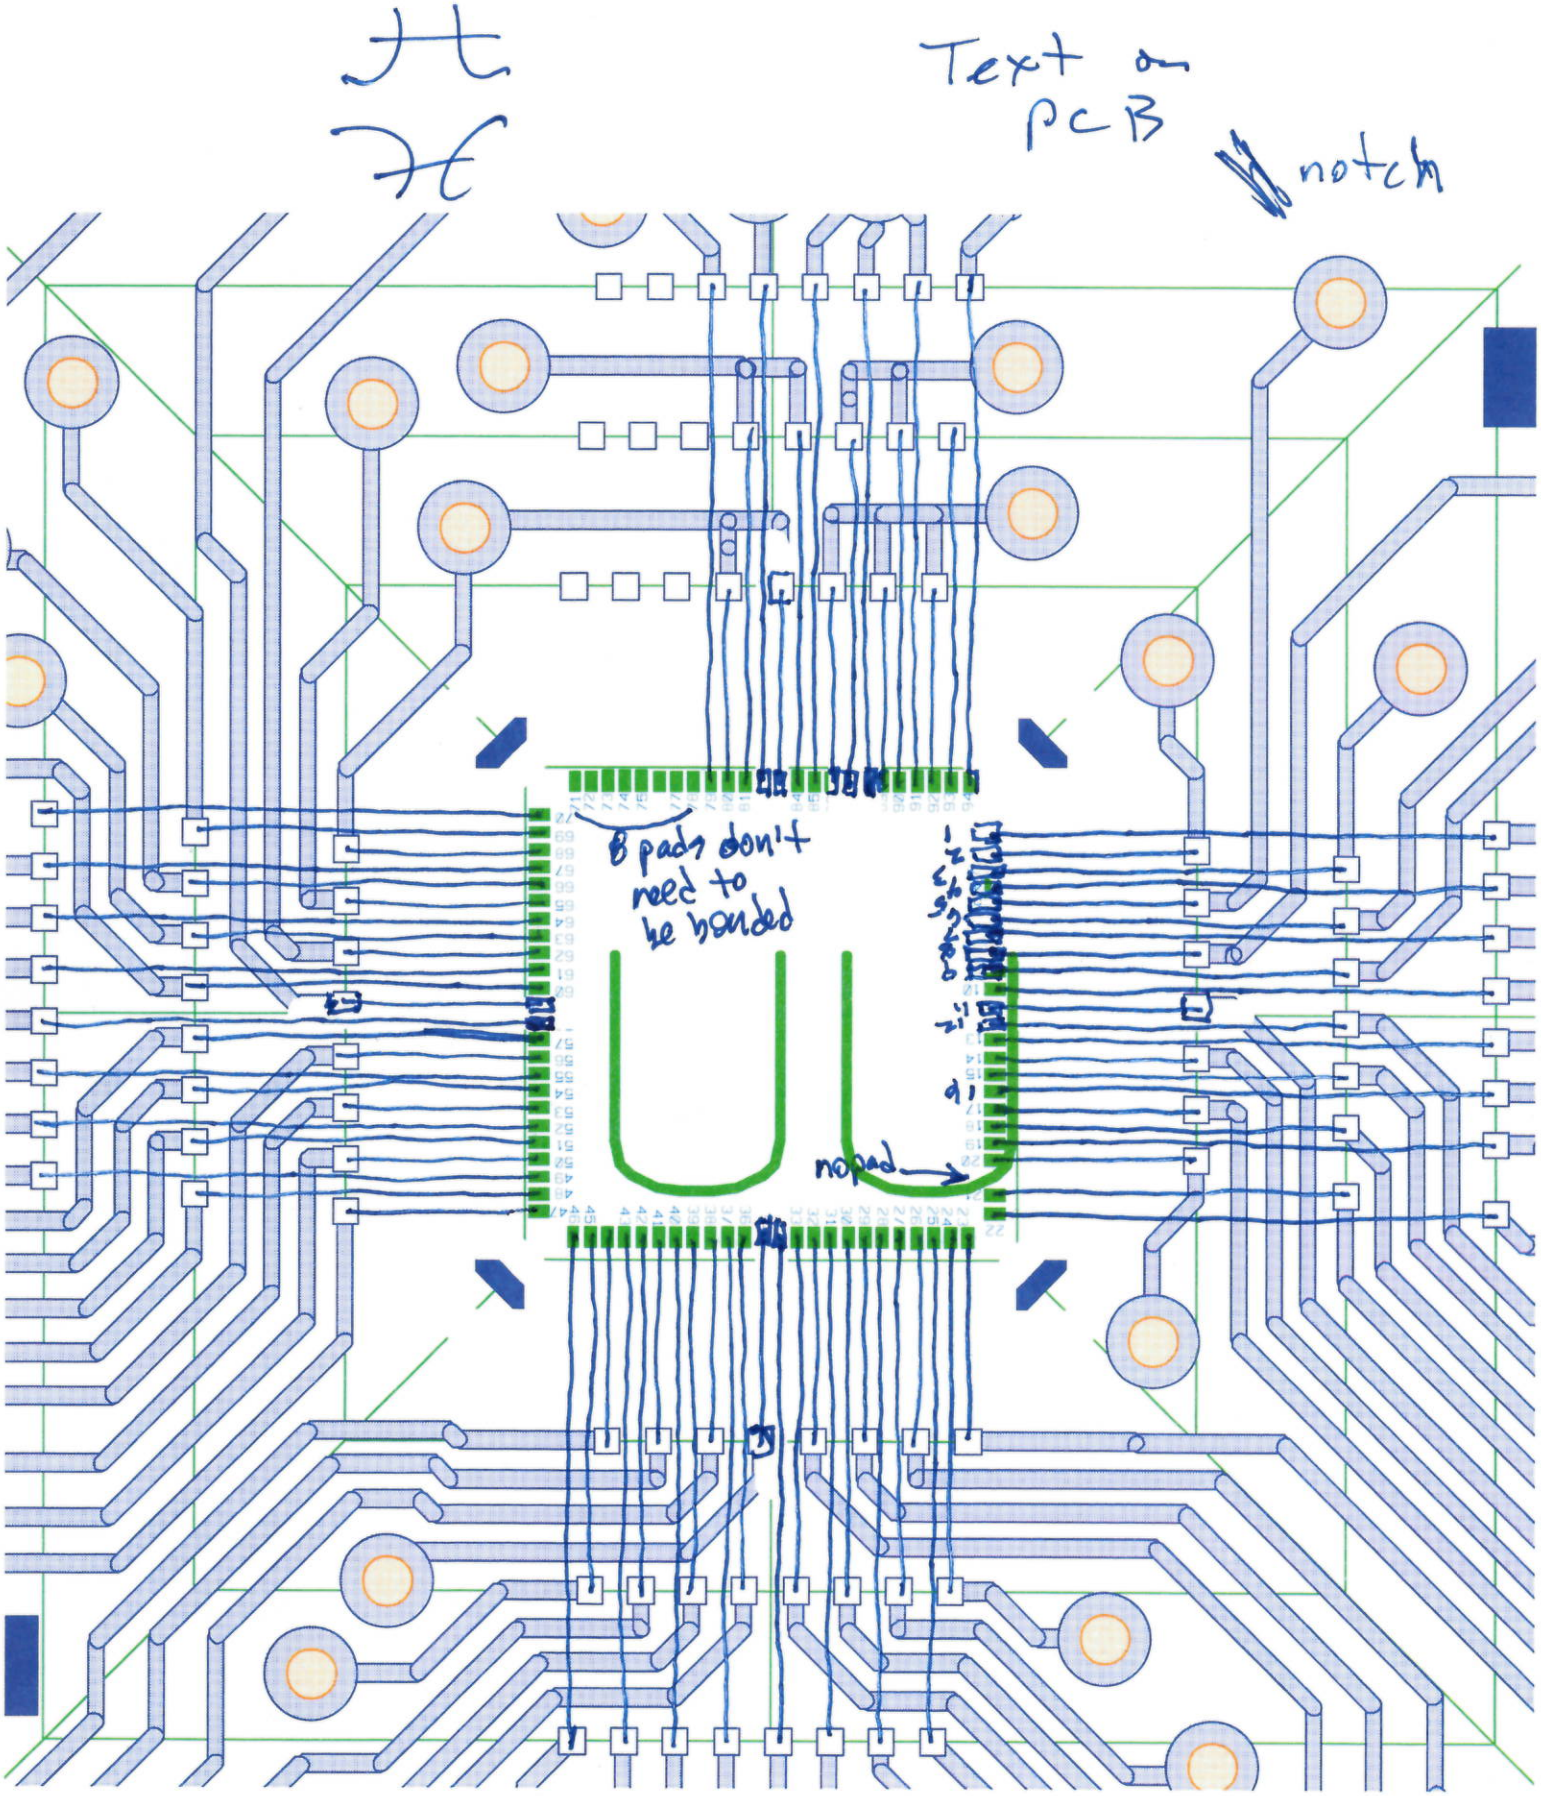
Text on PCB
notch
8 pads don't need to be bonded
no pad
